# Notice of Modification

## Section 75W of the *Environmental Planning and Assessment Act 1979*

The development consent (DA 305-7-2003) granted by the Minister Assisting the Minister for Infrastructure for Planning (Planning Administration) for the Wambo Coal Mine on 4 February 2004.

## APPENDIX 5 APPROVED LAYOUT

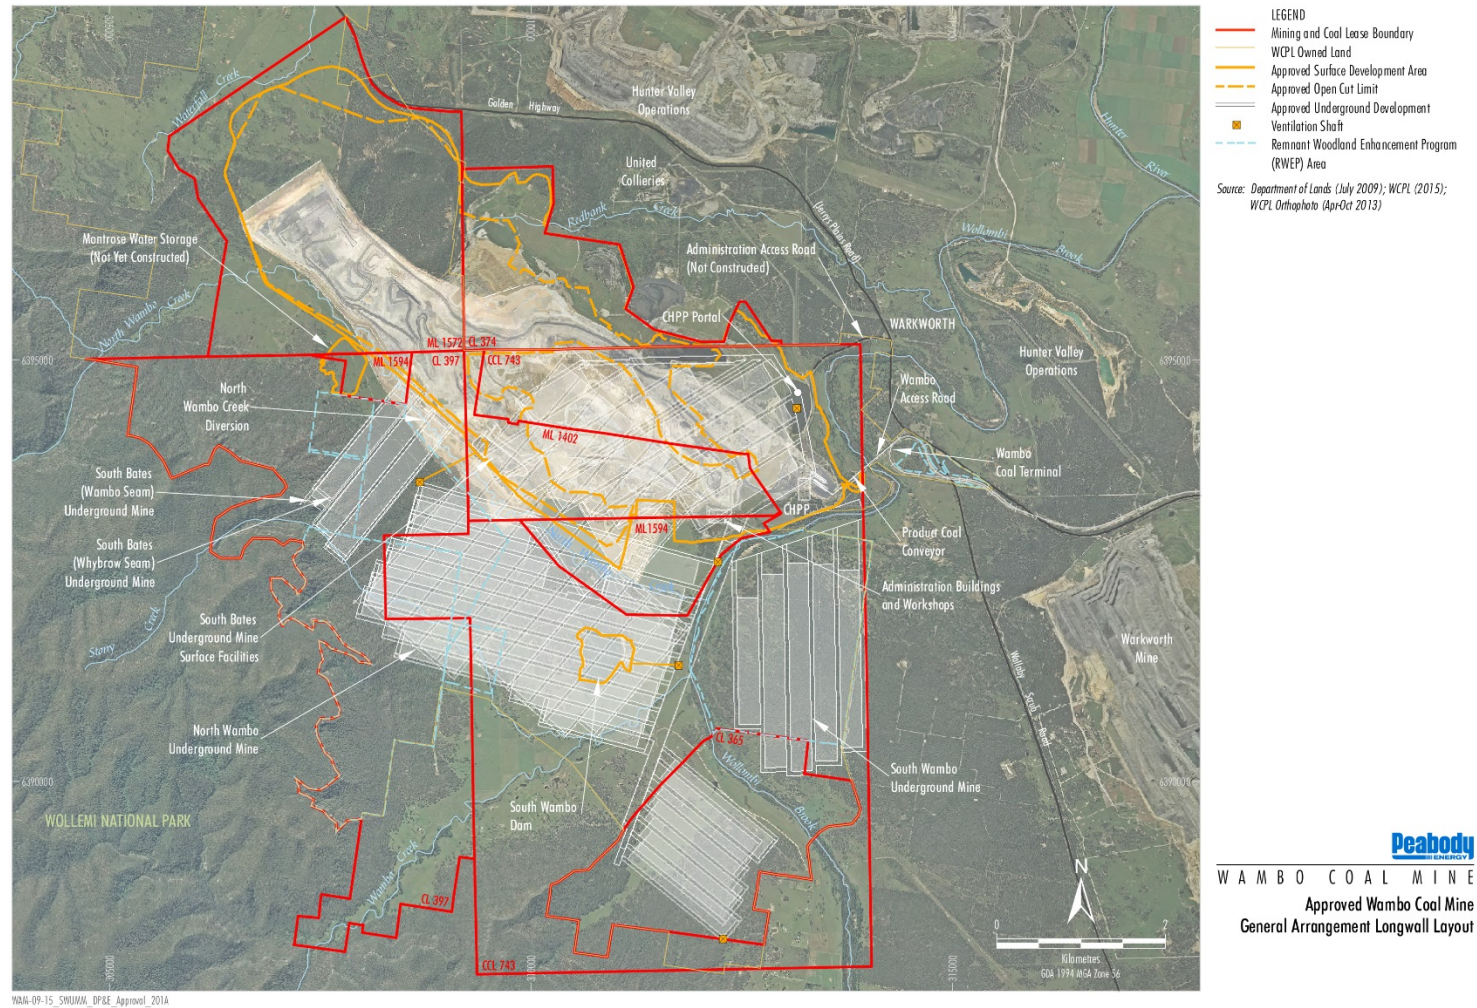
30. Replace Appendix 5, including the title, with the following:
